# PCN-20210132 TE0723-03 DDR3 Change and Product Update

<b>Company</b>	Trenz Electronic GmbH
<b>PCN Number</b>	PCN-20210132
<b>Title</b>	TE0723-03 DDR3 Change and Product Update
<b>Subject</b>	BOM change
<b>Issue Date</b>	2021-01-29

This change affects Trenz Electronic boards TE0723 of Revision 03: TE0723-03-\*

### #4 LEDs D6 and D7 changed to 19-213/G6C-BM1N2/DT

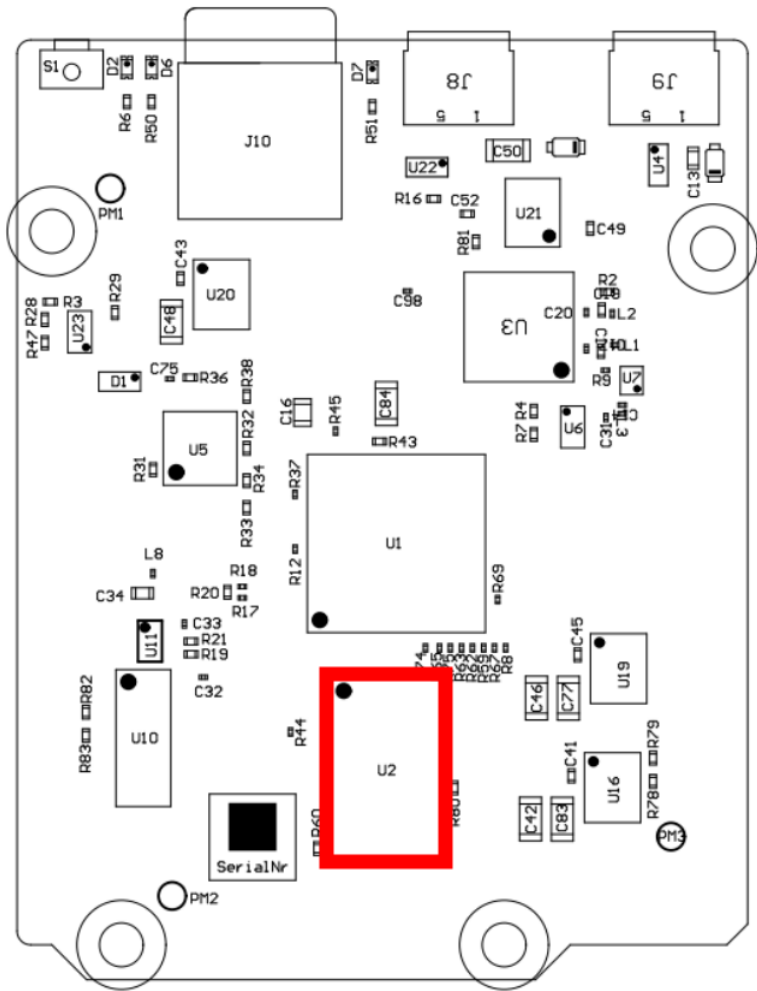
**Type:** BOM change  
**Reason:** Availability and cost optimisation.  
**Impact:** None.

Locate DDR3 RAM (U2) on top side of PCB:

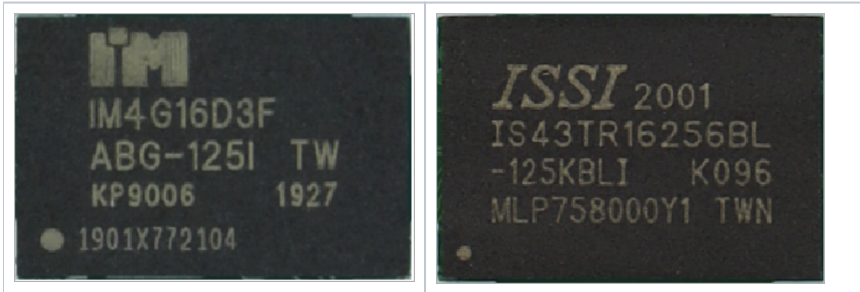
### #1 Change DDR3 RAM (U2) from IM4G16D3FABG-125I to IS43TR16256BL-125KBLI

**Reason:** Component is end of life.

**Impact:** New DDR timings may be considered in designs.

old	new
IM4G16D3FABG-125I	IS43TR16256BL-125KBLI
